Subject: Lakota Trailers Recreational Vehicle Power Awning Recall Notification

POTENTIAL DEFECT NOTIFICATION

PRODUCT RECALL

9100 POWER AWNING, WEATHERPRO AWNING AND MOTOR SERVICE KITS

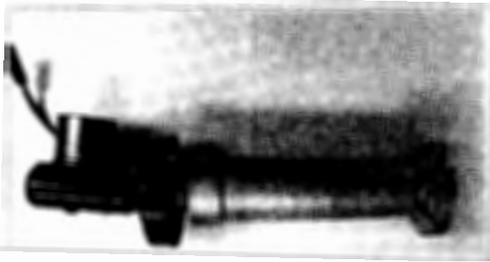
Background We recently introduced an enhanced redesign of certain components associated with the motor in our 9100 Power Awning & WeatherPro Awning and Motor Service Kits. There is an important step in our installation instructions which, in conjunction with our design change, CANNOT BE BYPASSED from the proper sequence (see below, as presented in our instructions).

! IMPACT OR PINCH HAZARD.
Removing cotter pin from torsion rod will attempt to spin the hardware and/or fabric roller tube quickly and unexpectedly. Failure to obey this warning could result in death or serious injury.

Remove cotter pin from left end of torsion rod (LH end cap). See (FIG. 6).

Removing cotter pin will release factory preset torsion (spring) tension.

Condition Through on-going testing, we have become aware that in some cases this step is being bypassed during installation. In bypassing this installation step the 9100 Power Awning, WeatherPro Awning, or Motor Service Kit installation can damage the awning motor. It is possible that the awning can unfurl unexpectedly, either while the coach is at rest

Awning Motor
This motor is affected by the product recall.

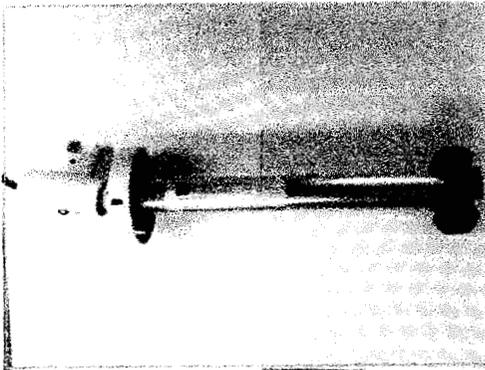
Awning Motor
Pre February 13, 2013. This motor is not affected by the product recall.

Serial Range 306xxxx to 314xxxx
Manufacturing Date Range
02/13/2013 to 04/09/2013

Awning Motor
Post April 9, 2013. This motor is not affected by the product recall.

Lakota's remedial action is to replace the motor assembly with another model that is not subject to an out-of-sequence installation problems and does not have screws holding the motor assembly together in such a way as to be vulnerable to torque-shearing.

Awning Motor
This motor is affected by the product recall.

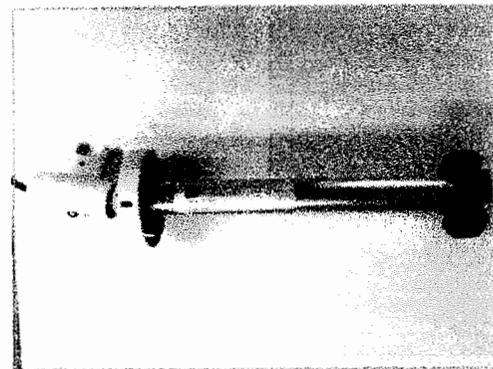
Awning Motor
Pre February 13, 2013. This motor is not affected by the product recall.

Serial Range 306xxxx to 314xxxx
Manufacturing Date Range
02/13/2013 to 04/09/2013

Awning Motor
Post April 9, 2013. This motor is not affected by the product recall.

Awning Motor-
This motor is affected by the
product recall.
Serial Range 306xxxx to 314xxxx
Manufacturing Date Range
02/13/2013 to 04/09/2013

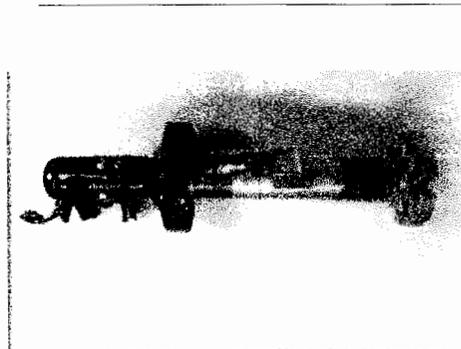
Awning Motor --
Pre February 13, 2013. This motor
is not affected by the product
recall.

Awning Motor-
Post April 9, 2013. This motor is
not affected by the product recall.
